## Accessibility Responsibilities Statement

**Project Title:** Proposed Alterations and Additions  
70 The Corso, Manly

**Report Version:** ARS\_9019\_v1.0

**PROJECT:** Proposed Alterations and Additions

**Figure 1 – Proposed Ground & First Floor**  
**Red highlights the subject stairway access to the First Floor area**

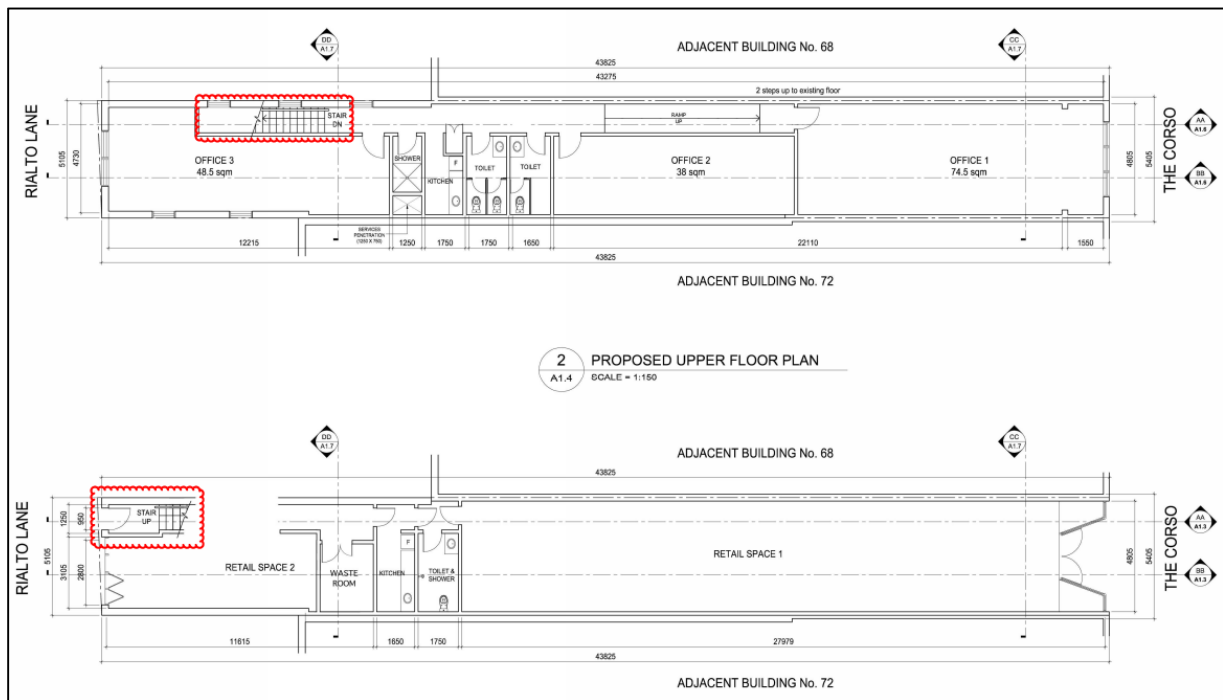
- Clause D3.1 of the BCA requires “access to be provided to and within all areas normally used by the occupants”.
- Clause D3.3 (f) (ii) of the BCA states that where a First Floor area of a 2 storey building exceeds a 200m<sup>2</sup> floor area, a ramp complying with AS1428.1-2009 or a passenger lift is required to be installed.
- The subject first floor area of the building is measured at approximately 220m<sup>2</sup>, therefore requiring an accessway.
- The lettable floor space area of the first floor area is 161m<sup>2</sup>.
- Stairway access will be the only means of access to the first floor area.

The above details the requirements and features of the accessway between the Ground and First floors. As such, some compliance departures have been identified by way of no accessway (via passenger lift) to the first floor area which has been requested to be addressed via a Performance Solution Report where possible.

No.	Performance Solution Scenario	DtS Provision	Performance Requirement
PS1	<p>The subject First Floor area has a 220m<sup>2</sup> floor area and is not proposed with an accessway via passenger lift/ ramp.</p> <p>The Performance Solution will be based on the fact there is a 161m<sup>2</sup> of lettable floor space area for a direct comparison of DtS provision D3.3 (f) (ii).</p> <p>This Performance Solution is subject to –</p> <ul style="list-style-type: none"> <li>The internal stairway achieving compliance with AS1428.1-2009.</li> <li>A lettable floor space area of less than 200m<sup>2</sup>.</li> </ul>	Cl. D3.1 & D3.3(f) (ii)	DP1
